PETITION

APPLICATION NO: 24/00050/NMA

**LOCATION: LAND TO THE NORTH-WEST OF WHITCHURCH HOSPITAL
PLAYING FIELDS**

PROPOSAL: Proposed Non-Material Amendment to Planning Permission 22/02231/RES - addition of TCAR2 emergency access route (to the SE of the site), removal of the Hollybush bridge, updates to the position of the intake room, and lowering of the basement level by 300mm.

Figure 2: Omission of the Hollybush Bridge and associated footpath, that also shows the approved HV intake room and revised position under this NMA

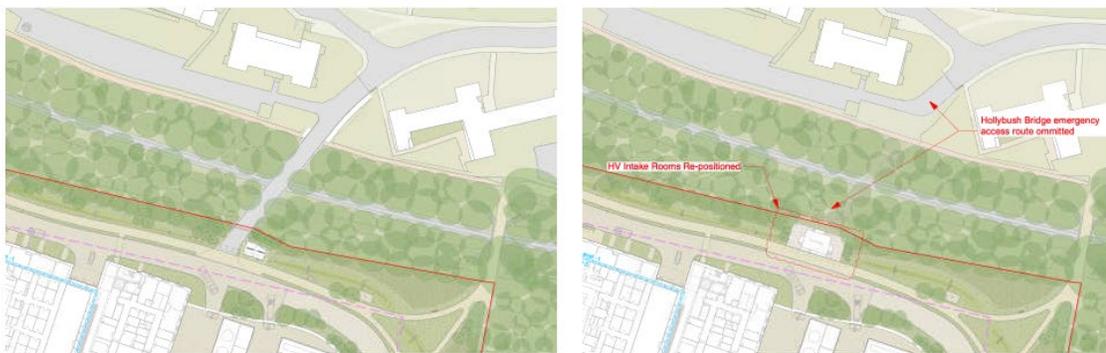
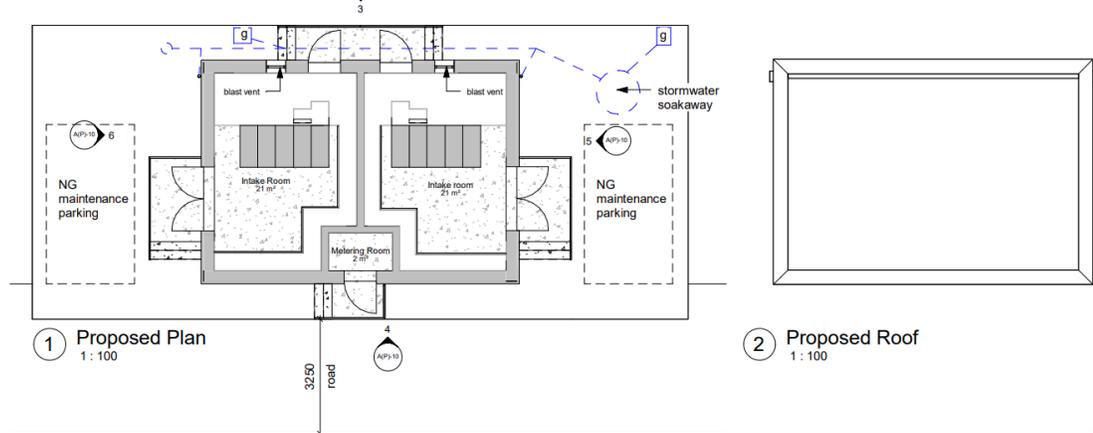
3.3 By way of background, the Reserved Matters consent identified two masterplan options – (Option A and Option B). Option A included the proposed emergency access bridge between the application site to the Hollybush Estate, which was also shown on the other approved drawings. Following the approval of the full application for the southern emergency access (see application 22/02280/FUL) the Hollybush bridge is no longer required and will not be built out (see figure 2 below).

Figure 3: Proposed HV building plans and elevations

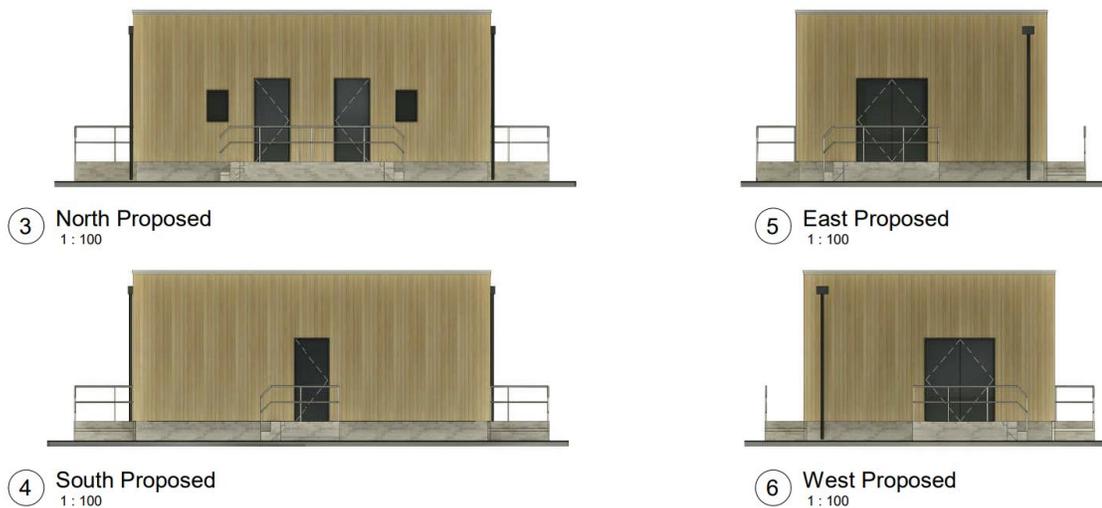
3.4 The HV generator intake room, would be realigned and configured to the northern boundary, in order to improve maintenance access/configuration for the intake room (see figure 3 below).

Figure 6: extent of change for proposed earthworks

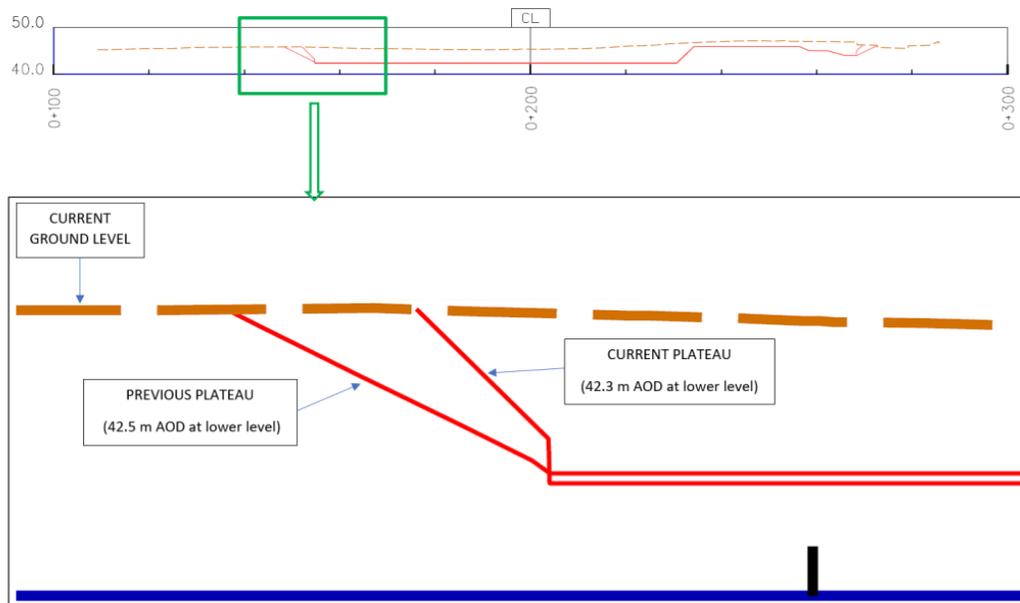
3.8 The supporting earthworks information states that the excavated building plateau has only been lowered by 200 mm throughout the design evolution, which has led to an improved structural solution, as well as an improved earthworks strategy to mitigate additional volume of ground to be excavated. It is calculated that the combination of the changes to the basement and method of working will result in a reduction in the volume of material that would be excavated (see figure 5).
